Dart Aerospace Ltd. Monday, 02/10/2006 7:16:03 AM Date: User: **Process Sheet** : SADDLE FITTING, AFT (OUTBOARD/INBOARD) : CU-DAR001 Dart Helicopters Services **Drawing Name** Customer Job Number : 28804 **Estimate Number** : 10533 : NA **Part Number** : D2573 P.O. Number : 02/10/2006 D2573 REV E This Issue S.O. No. : NIA **Drawing Number** : NC : N/A Prsht Rev. **Project Number** : WIT : MACHINED PARTS : E First Issue Type **Drawing Revision** :NIA : 28446 Material **Previous Run** : 09/10/2006 Fach Qty: 4 Um: **Due Date** Written By **Checked & Approved By** Comment As Per RevE 06-01-27 **Additional Product** Job Number: **Machine Or Operation: Description:** Seq. #: 1.0 D6101007 7075-T7351 8.25X7.75X2.5 Comment: Qty.: 1.0000 Each(s)/Unit Total: 4.0000 Each(s) 7075-T7351 8.25X7.75X2.5 Make from D6101-007 billet for D2573 Ensure that grain is along 7.75" length B25354 Batch No: HAAS1 HAAS CNC VERTICAL MACHINING #1 2.0 Comment: HAAS CNC VERTICAL MACHINING #1 Program Batch No 2804 Double check by: MS 1-Machine Step No 1 per Folio FA051 and inspect per attached Dimension Sheets 2-Machine Step No 2 per Folio FA051 and inspect per attached Dimension Sheets 3-Machine Step No 3 per Folio

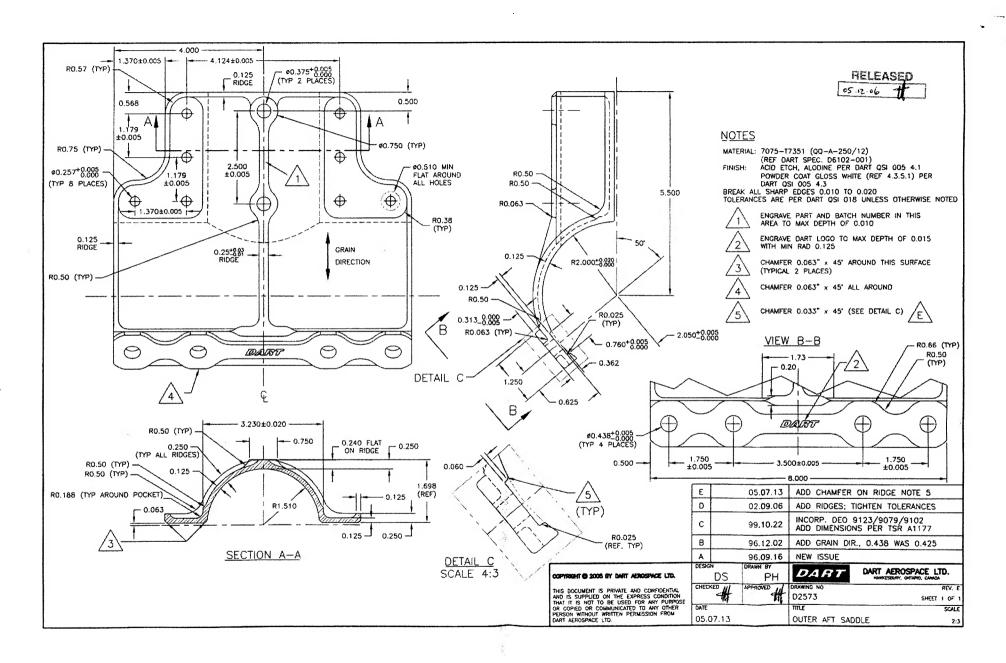
QA: N/C Closed:		Date: _	
NCR:		W	ORK OR	DER NON-CONFORMANC	E (NCR)			
DATE	STEP	Description of NC Section A	Initial Chief Eng	Corrective Action Section B  Action Description  Chief Eng	Sign &	Verification Section C	Approval Chief Eng	Approval QC Inspector
06/10/08	2	the thickness of the 1.510" Bore is under tolerance by 0.003"	(10)		\$6,0.53 00	06.1011	66.10.03 QSI 042	0010-11
								-
					3			,
